STAFF REPORT

RE: ZDO-270: Updates to Figures, Maps and Tables for Comprehensive Plan Chapter 5
Transportation System Plan

ZDO-270, Minor TSP Amendments

Figure 5 - 1d
Typical Urban Connector Cross Section

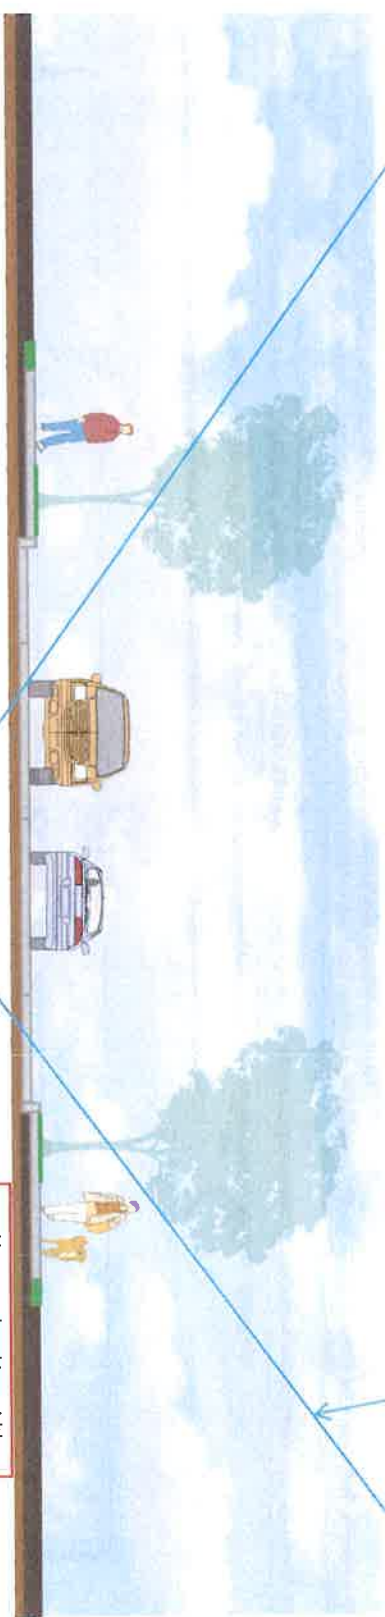
- Figure 5-1d, Typical Urban Connector/Local Cross Section – The Urban Connector Cross Section (previously Figure 5-1d) is the same as the Urban Local Cross Section (previously Figure 5-1e), so those have been combined in one cross section, and re-titled "Figure 5-1d, Typical Urban Connector/Local Cross Section".

- Travel lanes and parking lanes have been combined into one element to be consistent with the Clackamas County Roadway Standards.
 - Landscape strip and curb has been widened to 5'6" to accommodate a 5' landscape strip and 6" curb.

Figure 5 - 2a
Typical Rural Arterial Cross Section

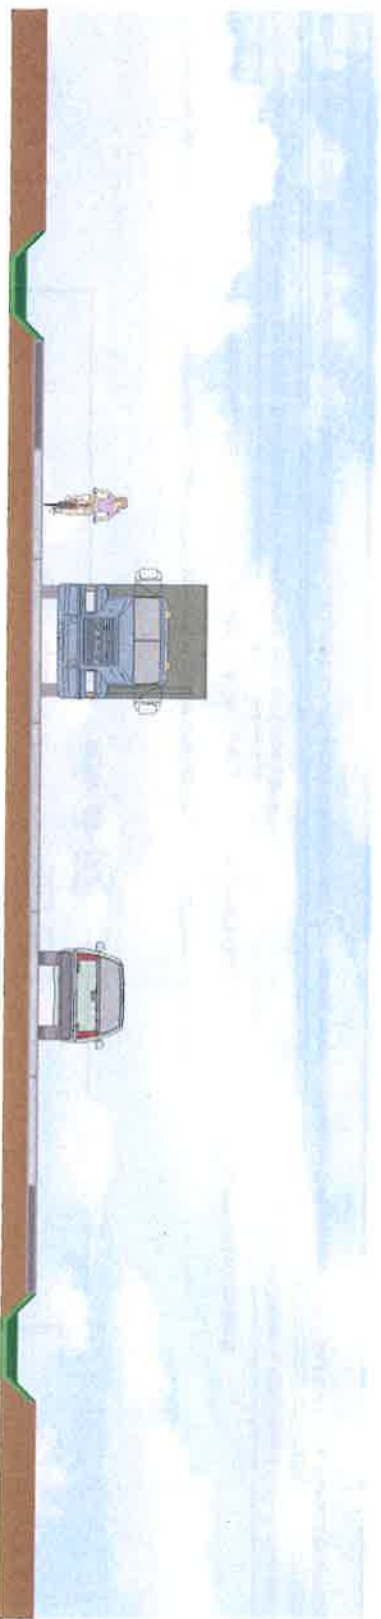
- Figure 5-2a, Typical Rural Arterial Cross Section
 - Left turn lane/median has been re-designated from "optional" to "as needed" to be consistent with Clackamas County Roadway Standards.

- Gravel shoulder altered to allow a narrower width if a "Paved shoulder/bikeway" is present.
 - Ditch has been re-designated from "optional" to "as needed" to be consistent with Clackamas County Roadway Standards and stormwater requirements.

Figure 5 - 2b
Typical Rural Arterial Cross Section
Unincorporated Communities

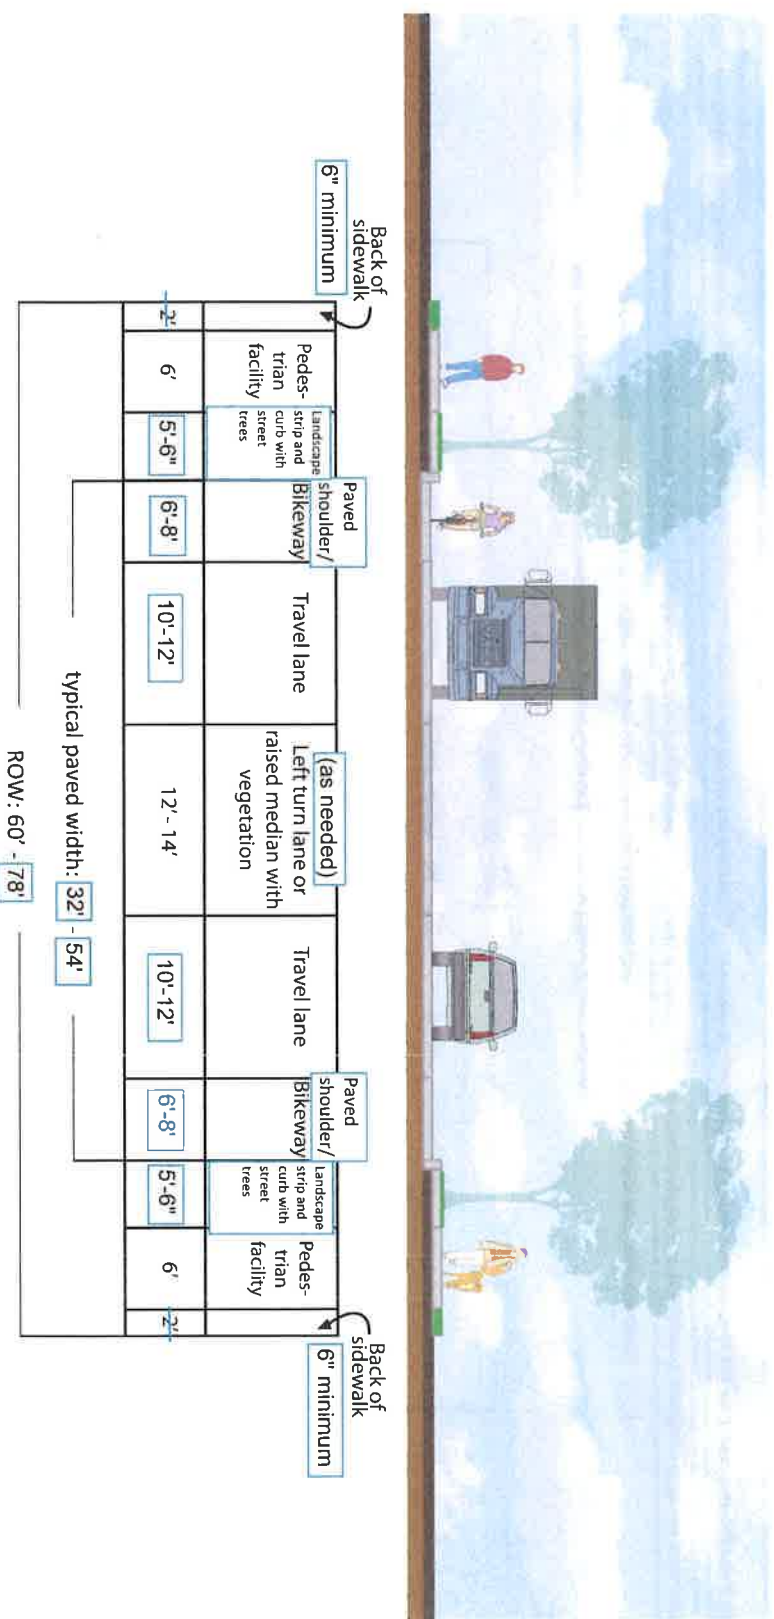
- Figure 5-2b, Typical Rural Arterial Cross Section Unincorporated Communities
 - Left turn lane/median has been re-designated from "optional" to "as needed" to be consistent with Clackamas County Roadway Standards.

- Paved shoulder/bikeway width has been revised to conform to national standards and the provisions of the Active Transportation Plan.
 - Landscape strip and curb has been widened to 5'6" to accommodate a 5' landscape strip and 6" curb.

Figure 5 - 2d
Typical Rural Collector Cross Section
Unincorporated Communities

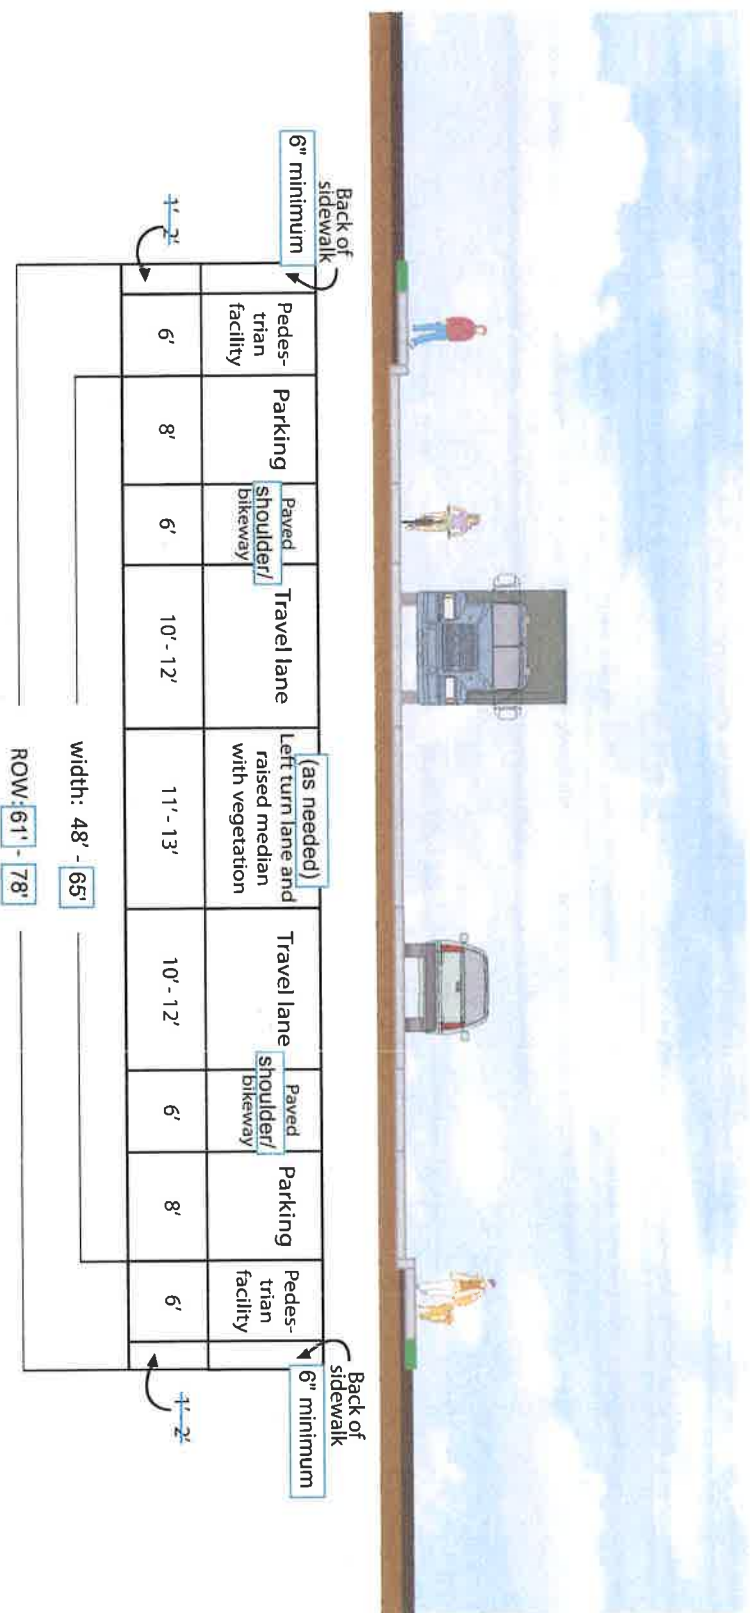
- Figure 5-2d, Typical Rural Collector Cross Section Unincorporated Communities
 - Left turn lane/median has been re-designated from “optional” to “as needed” to be consistent with Clackamas County Roadway Standards.

- Paved shoulder bikeway has been revised to “Paved shoulder/bikeway” to be consistent with the Active Transportation Plan and with other cross sections.

Figure 5 - 2e
Typical Rural Connector/Local Cross Section

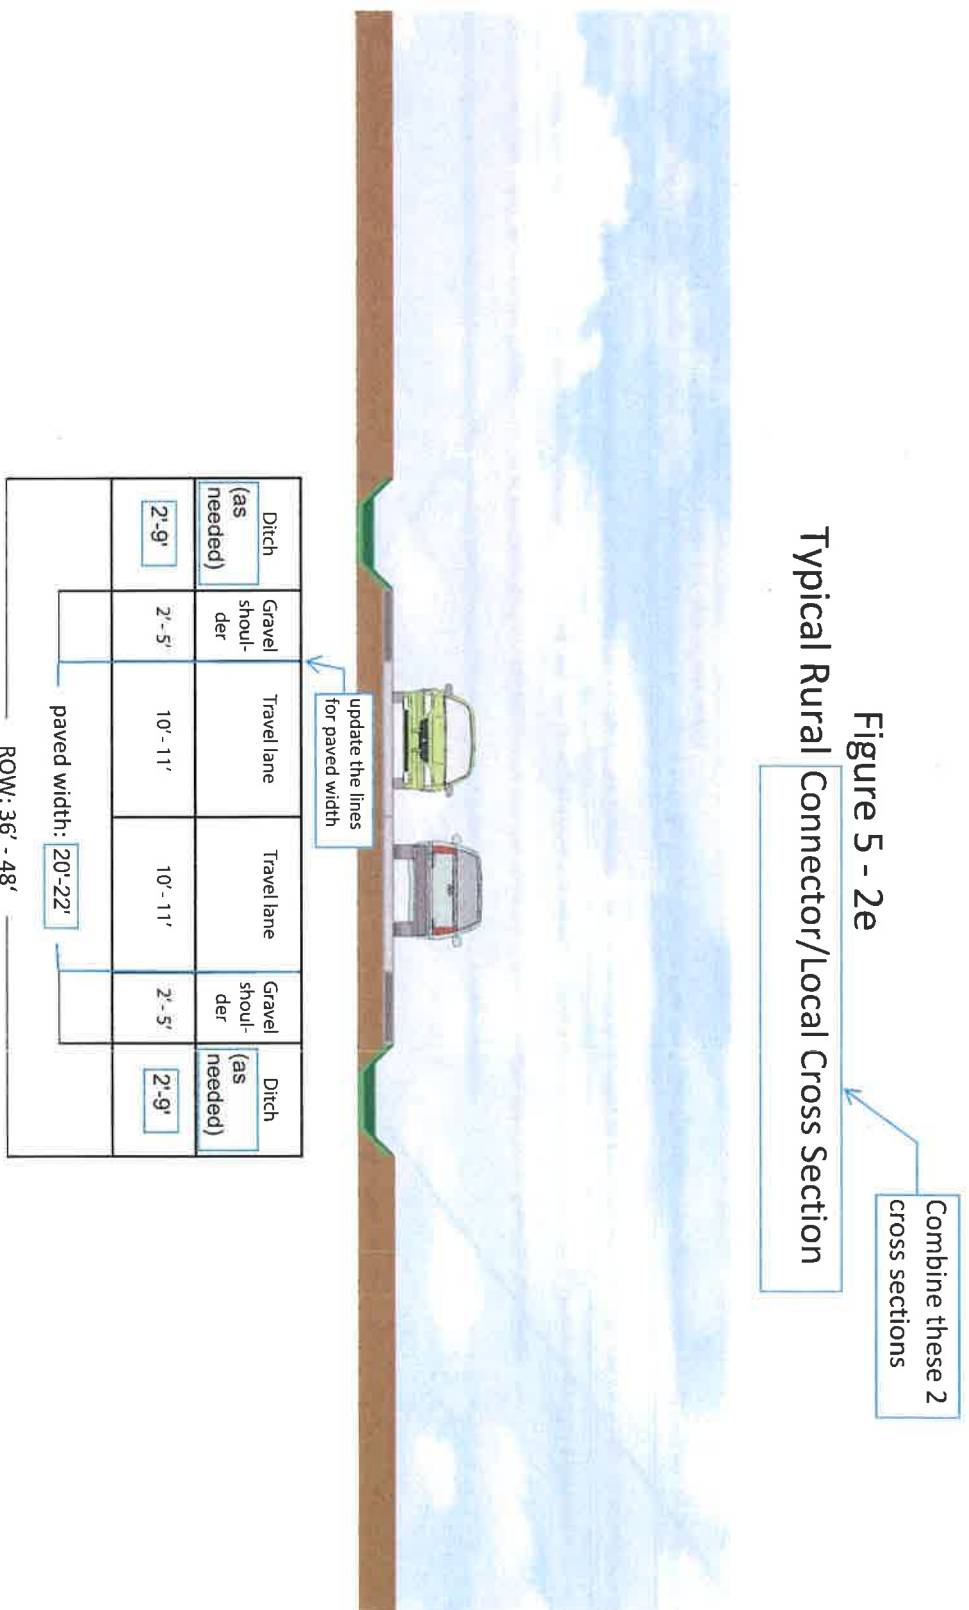
- Figure 5-2e, Typical Rural Urban Connector Cross Section – The Rural Connector Cross Section is the same as the Local Cross Section, so those have been combined in Figure 5-2e.

- Figure 5-2f, Typical Rural Connector/Local Cross Section
 - Paved width was incorrectly shown in the adopted version to include the gravel shoulders. In the proposed revised diagram “paved width” only applies to the paved section of the road and does not include the gravel shoulder width. This change simply corrects a previous mistake and neither the travel lane width nor the gravel shoulder width are proposed to change.

- Ditch has been re-designated from “optional” to “as needed” and width range has been widened from 6’ to 8’ in the adopted, to a proposed 2’ to 9’ to be consistent with Clackamas County Roadway Standards and stormwater requirements.

Figure 7-1A

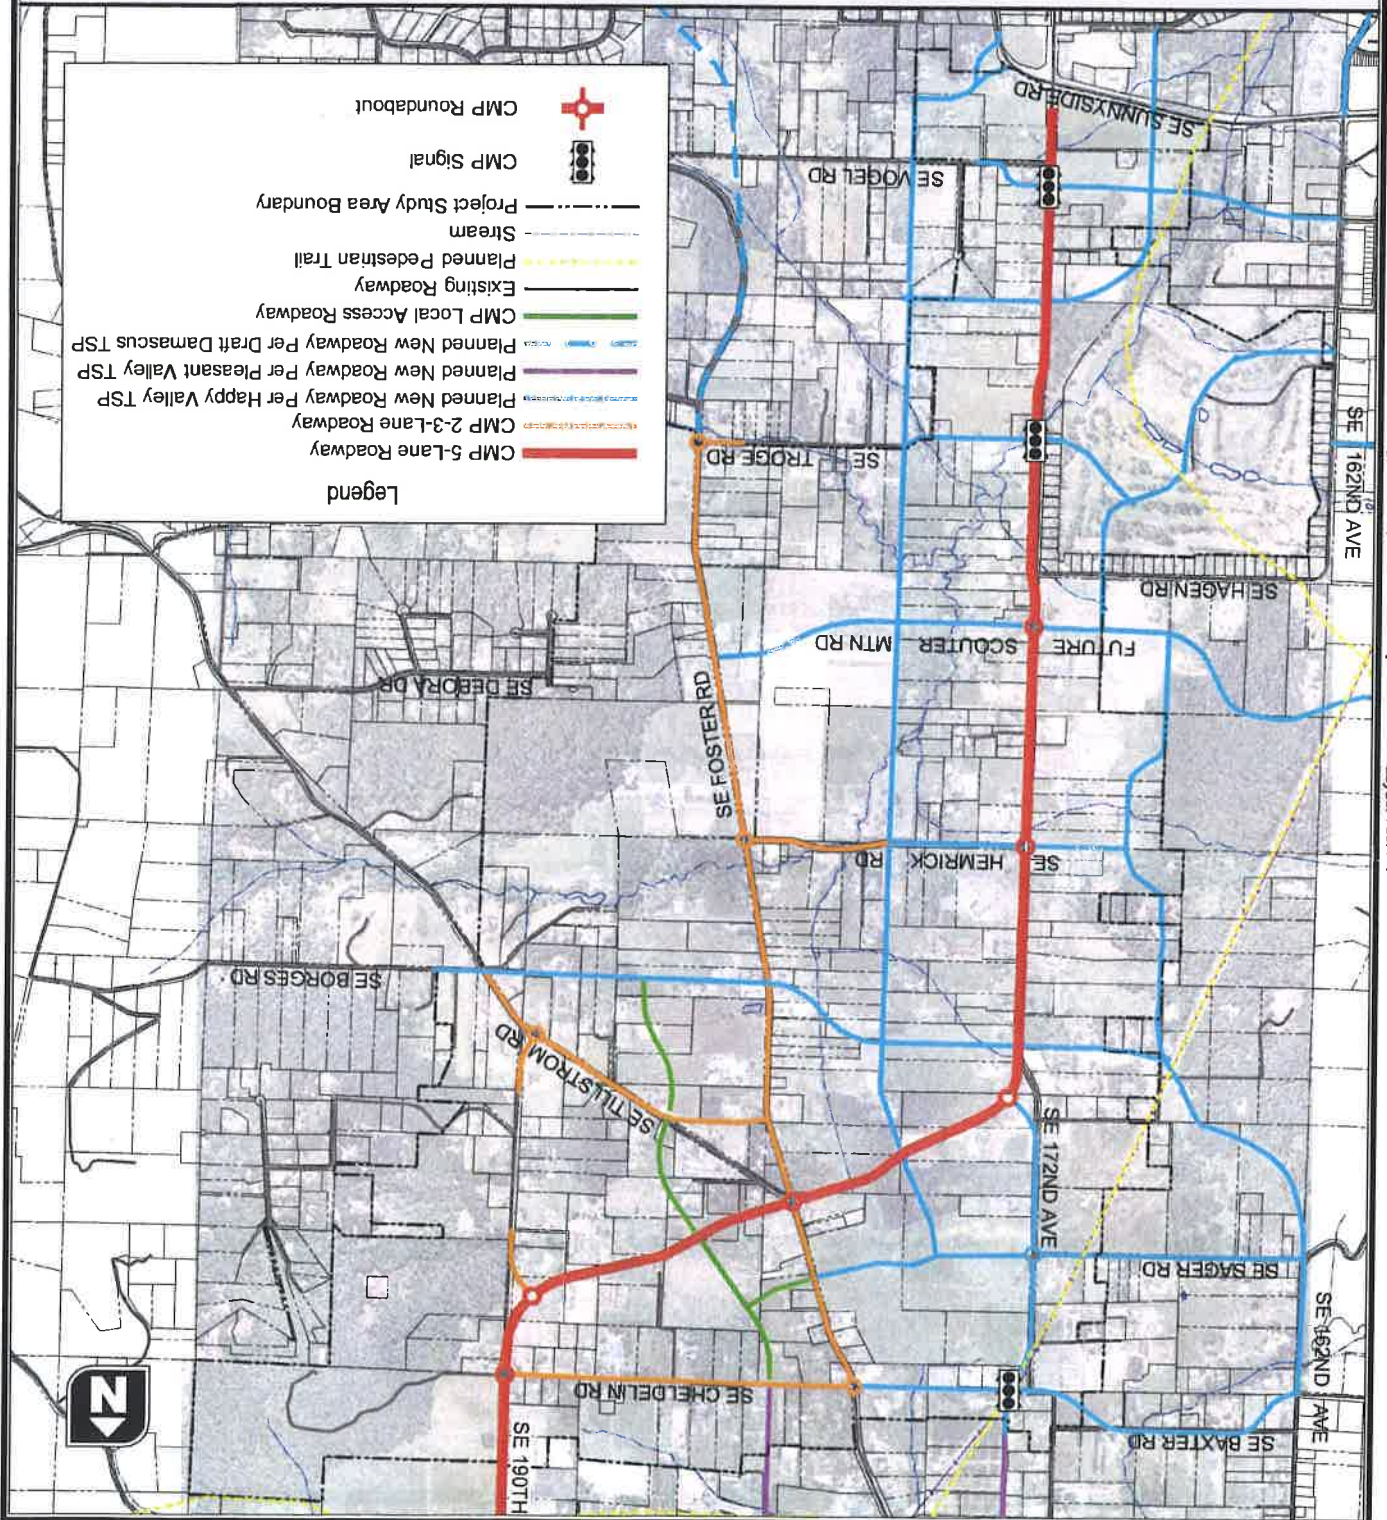
- e. **Revisions to Figures 7-1A, 7-1B, 7-2A through 7-2D, and 7-3A** – In their most recent Transportation System Plan update, Happy Valley revised several roadway network designations and cross sections, which had been included in the SE 172nd/190th Drive Corridor Management Plan. Since those were amended in the city TSP, and the corridor has been annexed into the City of Happy Valley it was necessary to amend them in the Corridor Management Plan to maintain consistency. Although Clackamas County has no authority over roadway network designations and cross sections in Happy Valley, it is necessary for the county to adopt the updated Corridor Management Plan that includes those changes.

MAP 5-11a

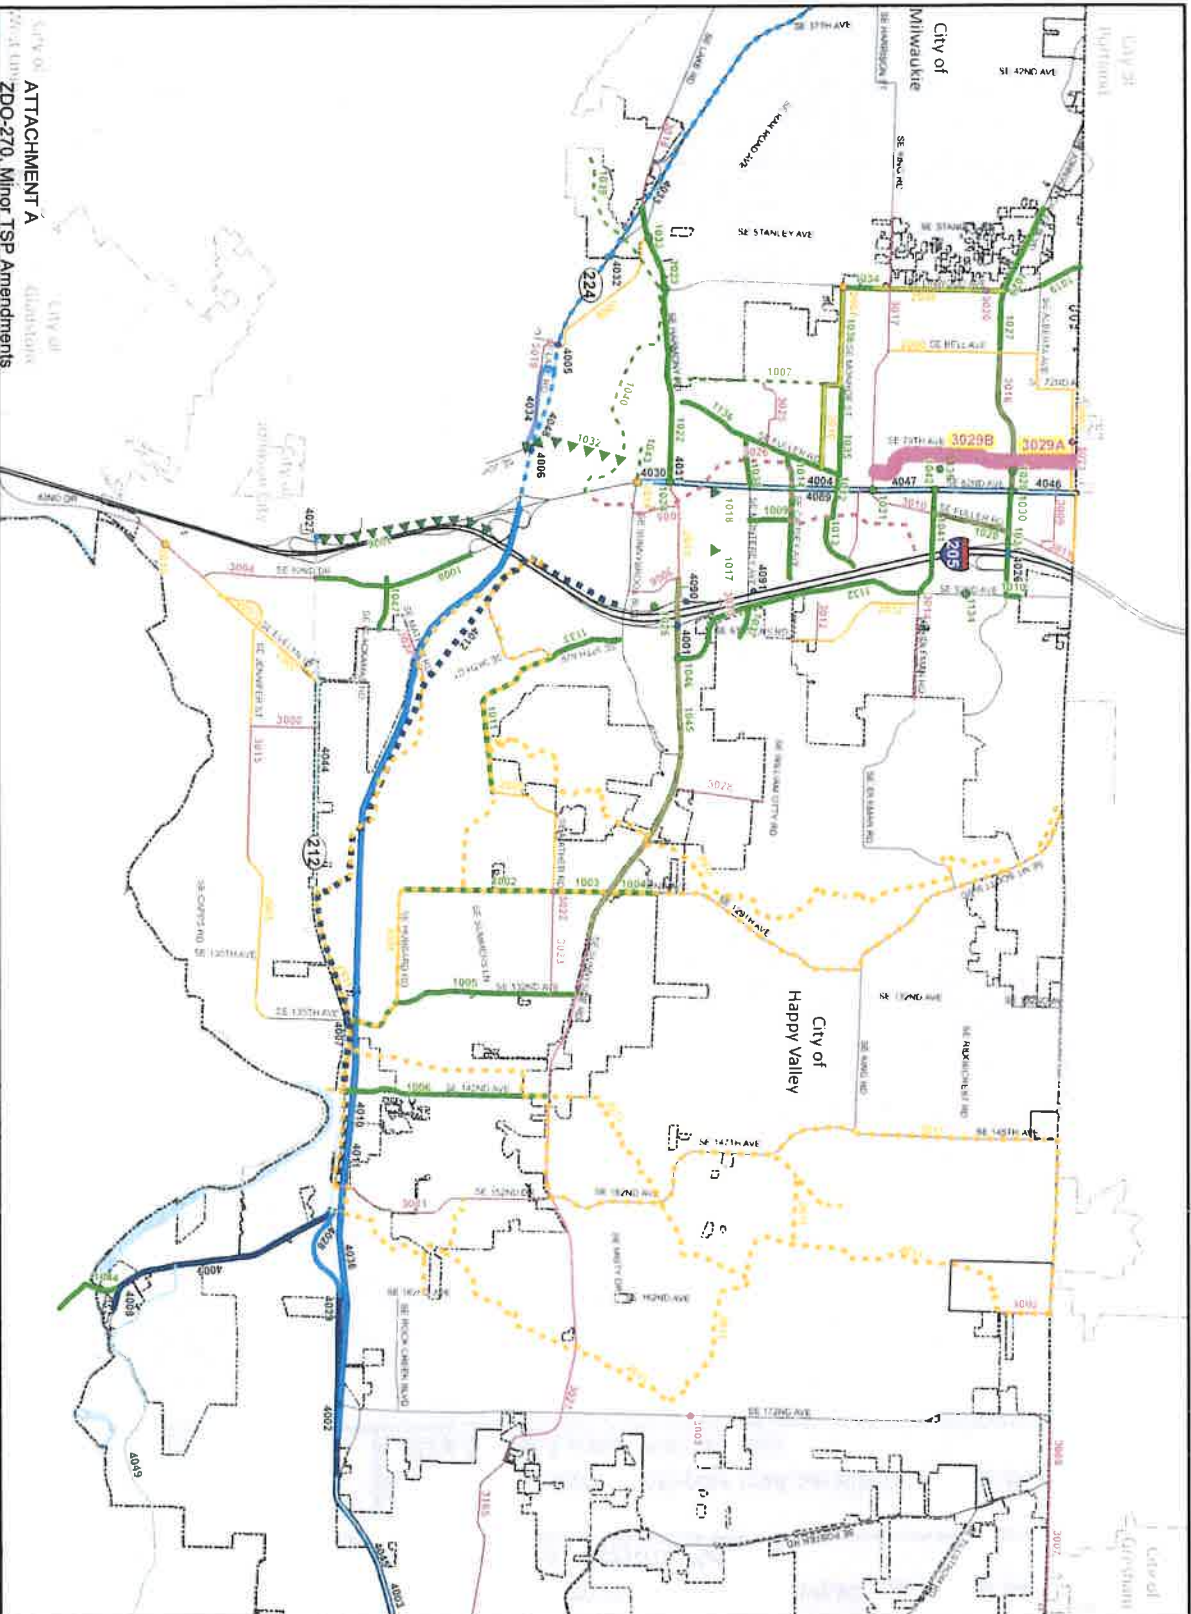
The project proposed to be modified is #3029, which is named the “West 82nd Ave Parallel Road”, extends from King Road to Luther Road and is described as follows: “Construct collector road parallel to OR213 with bikeways and pedestrian facilities.” The intent of this proposed TSP project is to improve access for local traffic, pedestrians and bicyclists in this neighborhood without the necessity of using 82nd Ave/OR213. This proposed modification would replace #3029 with #3029a and #3029b. Both replacement projects would have the same project name (West 82nd Ave Parallel Road) and the same description (see attached table). New project #3029a would extend from Luther Road to Johnson Creek Boulevard, and new project #3029b would extend from Johnson Creek Boulevard to King Road (see attached map).

As a result, the best way to ensure the applicant meets their responsibilities to provide adequate transportation system capacity is to enable the construction of the portion of project #3029 between Luther Road and Johnson Creek Blvd. Enabling the construction of that segment of project #3029 requires that the project be split into two sections, #3029a and #3029b as described on the previous page, and shown in the attached table and map.

If this proposed amendment is approved it will be incorporated into Comprehensive Plan, Chapter 5 – Transportation System Plan by modifying Table 5-3c Long Term Capital Projects and Map 5-11a to remove Project ID #3029 and replace it with two projects with the same description: #3029a extending from Luther Road to Johnson Creek Boulevard, and #3029b extending from Johnson Creek Boulevard to King Road.

3. Modify Table 5-3c Long Term Capital Projects and Map 5-11a to remove Project ID 3029 extending from Luther Road to King Road and replace it with two projects: a) Project ID 3029a extending from Luther Road to Johnson Creek Boulevard; b) Project ID 3029b extending from Johnson Creek Boulevard to King Road.
